# Access Compliance Report

## Public Rights-of-Way

### (Curb Ramps)

Intersection ID: 9720	Main Street: N_GARDNER_AV	Cross Street: SELDON_DR	Location:	W
ADA ID: A2B3E5B92D19	Ramp Type: BlendTrans1	Initial Pass/Fail: Fail	Overall Compliance: No	Severity Score: 10
Codes/Mitigation Info/Possible Solution		Field Measurements/Component Compliance

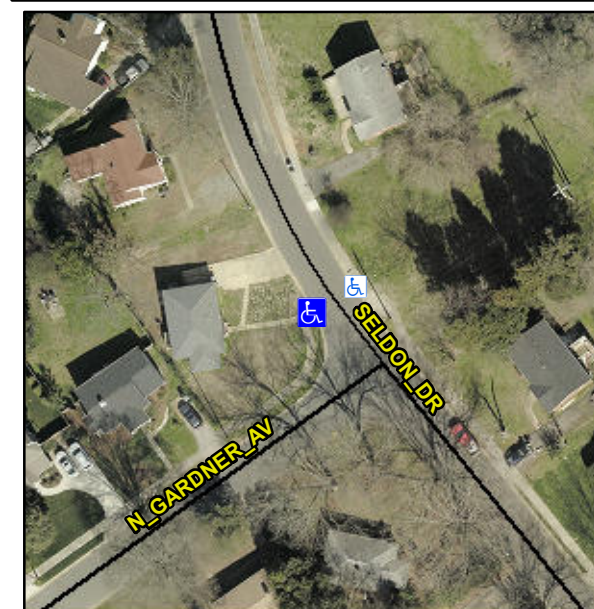
**Not Found, R304.5.1**

Compliance	Description	Data	Compliance	Description	Data
N/A	Ramp Length (in)	48.0	Yes	BlendTrans Slope (%)	3.2
No	Ramp Width (in)	47.5	Yes	BlendTrans XSlope (%)	3.0
N/A	Flare Type LT	N/A	N/A	Flare Type RT	N/A
N/A	Flare Slope LT (%)	N/A	N/A	Flare Slope RT (%)	N/A
N/A	Flare Traversable LT?	N/A	N/A	Flare Traversable RT?	N/A
N/A	Landing Length (in)	N/A	N/A	DWS Provided?	N/A
N/A	Landing Width (in)	N/A	N/A	DWS Contrast?	N/A
N/A	Landing Slope (%)	N/A	N/A	DWS Length (in)	N/A
N/A	Landing X Slope (%)	N/A	N/A	DWS Full Width?	N/A
N/A	Landing Curb? (Y/N)	N/A	N/A	DWS Offset (in)	N/A
N/A	Shared Landing?	N/A			
N/A	Gutter Ponding?	N/A	N/A	Gutter Slope (%)	N/A
N/A	Gutter Lip Ht (in)	0.5	N/A	Gutter X Slope (%)	N/A
N/A	Painted X Walk1?	No	N/A	Painted X Walk2?	N/A
	X Walk 1 Direction	To E		X Walk 2 Direction	N/A
	X Walk 1 Width (in)	N/A		X Walk 2 Width (in)	N/A
	X Walk 1 Slope (%)	3.5		X Walk 2 Slope (%)	N/A
	X Walk 1 X Slope (%)	4.0		X Walk 2 X Slope (%)	N/A

N/A	Ramp inside XWalk1?	N/A	N/A	Ramp inside XWalk2?	N/A
	Road Slope (%)	4.0		Clear Space?	N/A
	Road X Slope (%)	3.5	N/A	Clear Space to XWalk (in)	N/A
N/A	Any Obstructions?	N/A	N/A	Storm Grate/Utility Hazard?	N/A
	Obstruction Type			Storm Grate/Utility Type	
		N/A			N/A
			Yes	Surface Condition? (G/P)	Good
			No	Curb Slope (%)	15.1

**Remove & Replace Curb Ramp With Two New Directional Ramps or Equivalent.**
